# TP-LINK CORPORATION PTE.LTD.

Subject: Requesting Class II permissive change for FCC ID: 2BCGWBE230

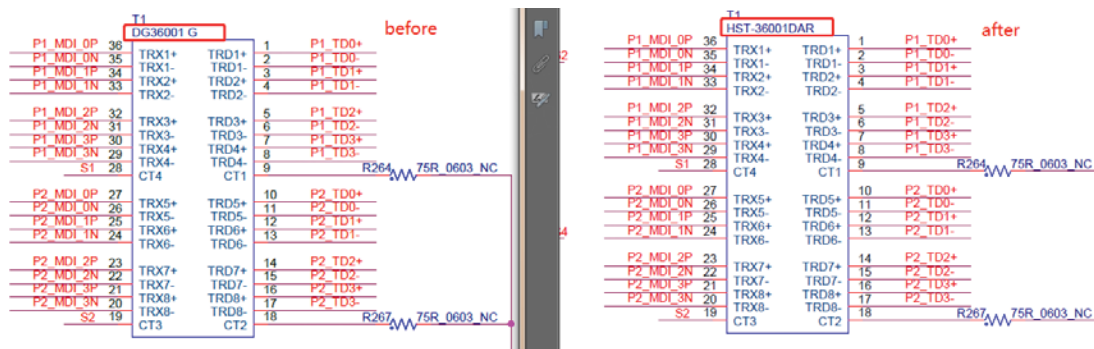
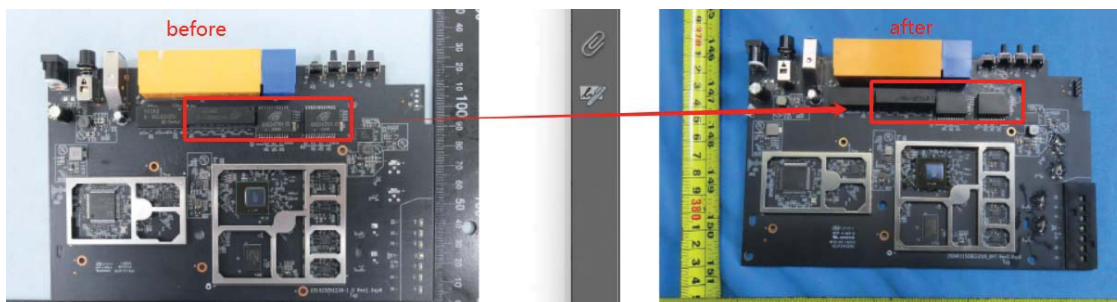
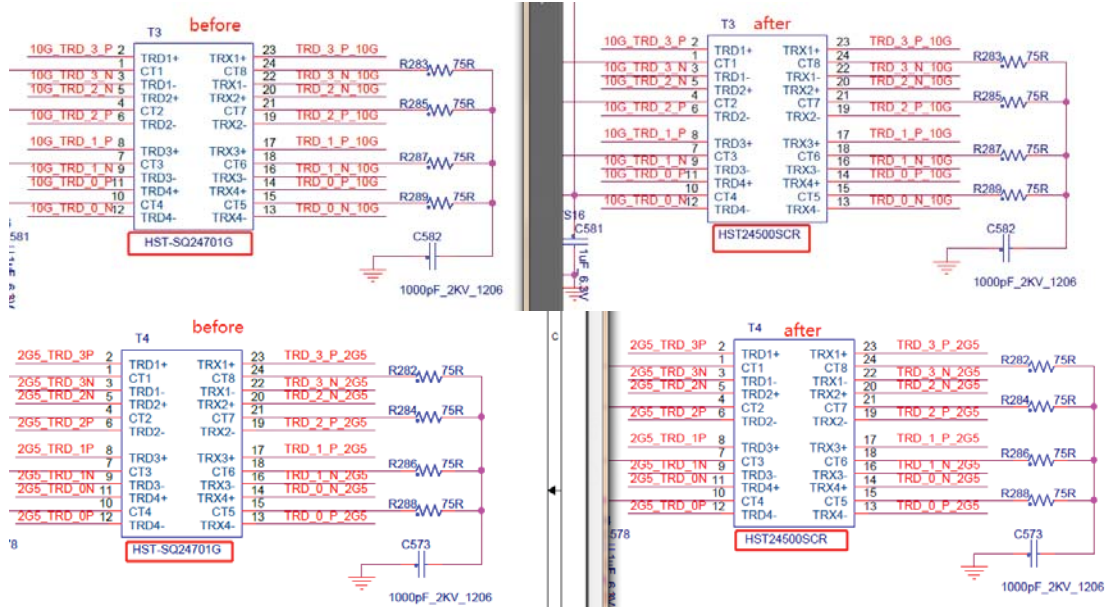
1. Change the signal transformer of the network port.(Update transformer model number.)

The model of transformer T3,T4 & T1 has been updated to HST24500SCR & HST-36001DAR.
